DATE: 11.13.2018
TO: ProTrak
FROM: Mitesh Baxi
Traffic Engineering

CALIBRATION STATION OFFICES [TRC Plan Review #4]

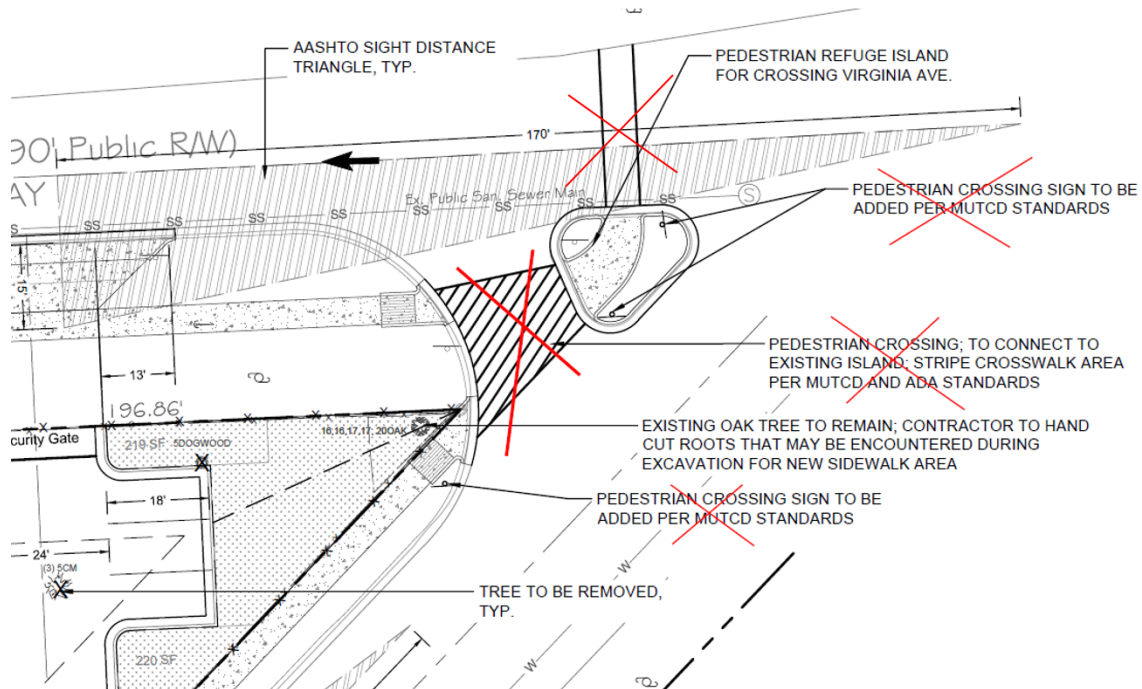
1. Show the City's 20'x70' sight distance triangle for all the driveways as per previous comments. Revise as per below image. Show the City's 46'x46' sight distance triangle at each street corner intersection abutting this property on site and landscape plans. [Sec.18-529(c)(3)CofW LDC]

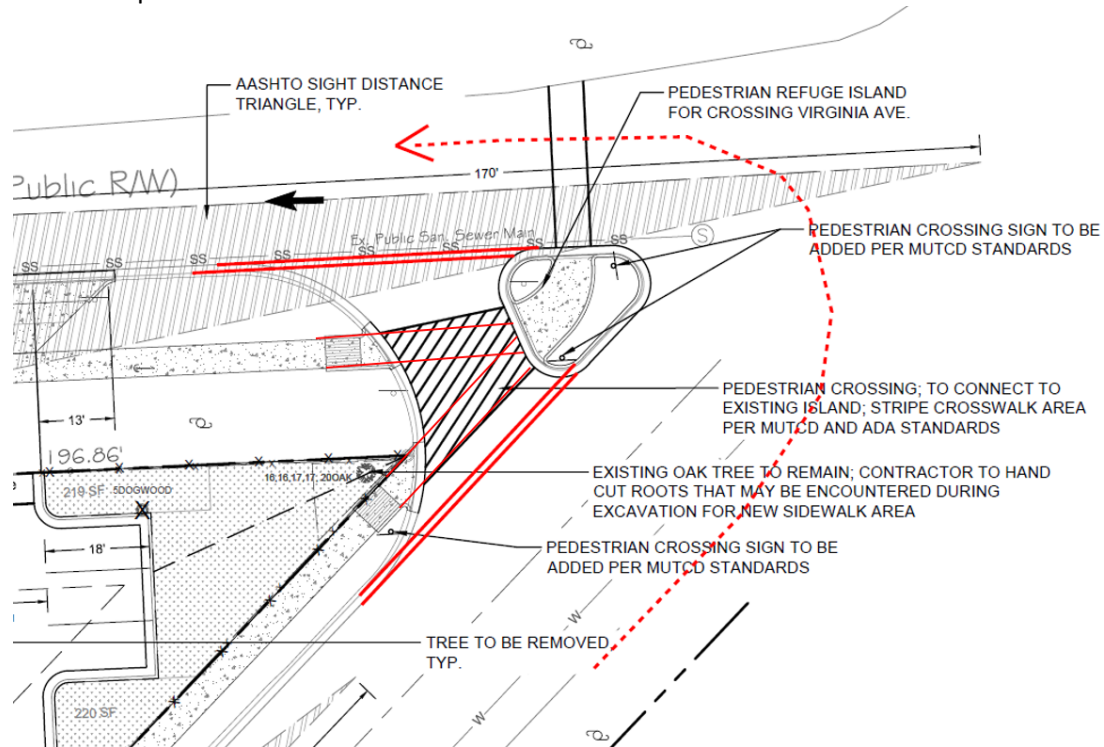
2. Ramp for the refuge island shall be installed as per ADA/City standards. Show the warning domes for the ramps.
3. Crosswalk pavements markings leading to the Refuge Island and pedestrian warning signage are not required.

4. *Option:* Extend the curb/gutter and sidewalk up to the refuge island. Provide the turning movement analysis into Virginia Ave as shown below. Developer may be required to reshape the refuge island to facilitate the safe turning movement. Area between refuge island and property boundary will still remain as public ROW.
